**FEDERAL FACILITY AGREEMENT AND CONSENT ORDER (FFACO)
RECORD OF TECHNICAL CHANGE (ROTC)**

Corrective Action Unit (CAU) Number: 415

CAU Description: Project 57 No. 1 Plutonium Dispersion (NTTR)

ROTC No.	<u>DOE/NV--1581-ROTC 2</u>	Page	<u>1</u>	of	<u>10</u>
Document Type	<u>Closure Report (CR)</u>	Date	<u>11/19/2019</u>

**CAU 415, CAS NAFR-23-02
Pu Contaminated Soil
FFACO UR Boundary**

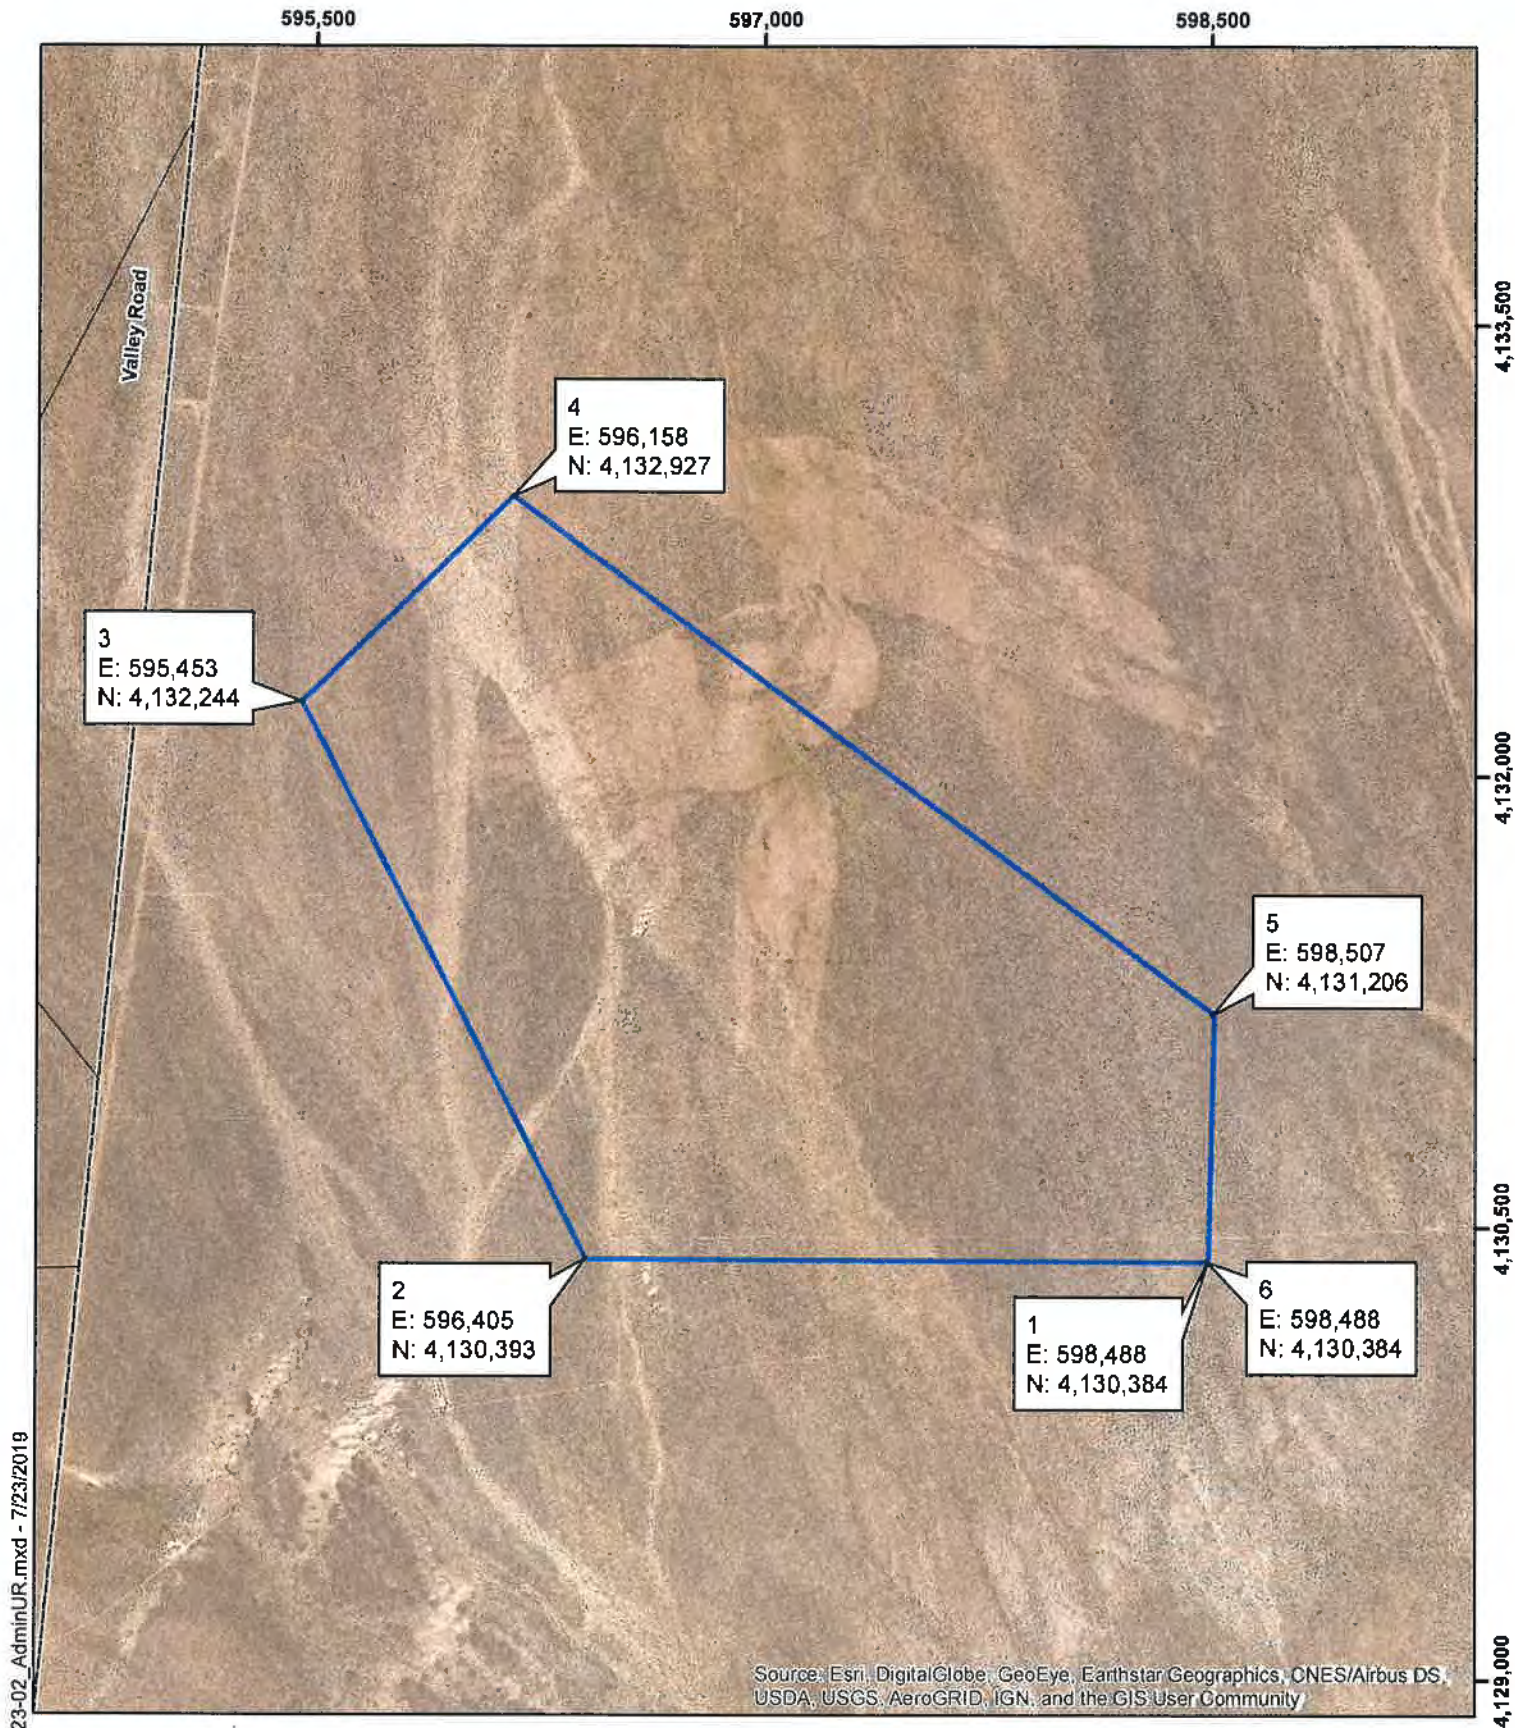
1. This ROTC replaces the Use Restriction (UR) information listed in the documentation for CAU 415.

UR forms have been updated to list all UR requirements, including but not limited to: post-closure site controls (signs, fencing, etc.), inspection and maintenance requirements, and Geographic Information Systems (GIS) coordinate information. The UR requirements and form(s) included in this ROTC represent the current corrective action requirements for each Corrective Action Site (CAS) in this CAU and supersede information concerning corrective action and post-closure requirements in existing documentation.
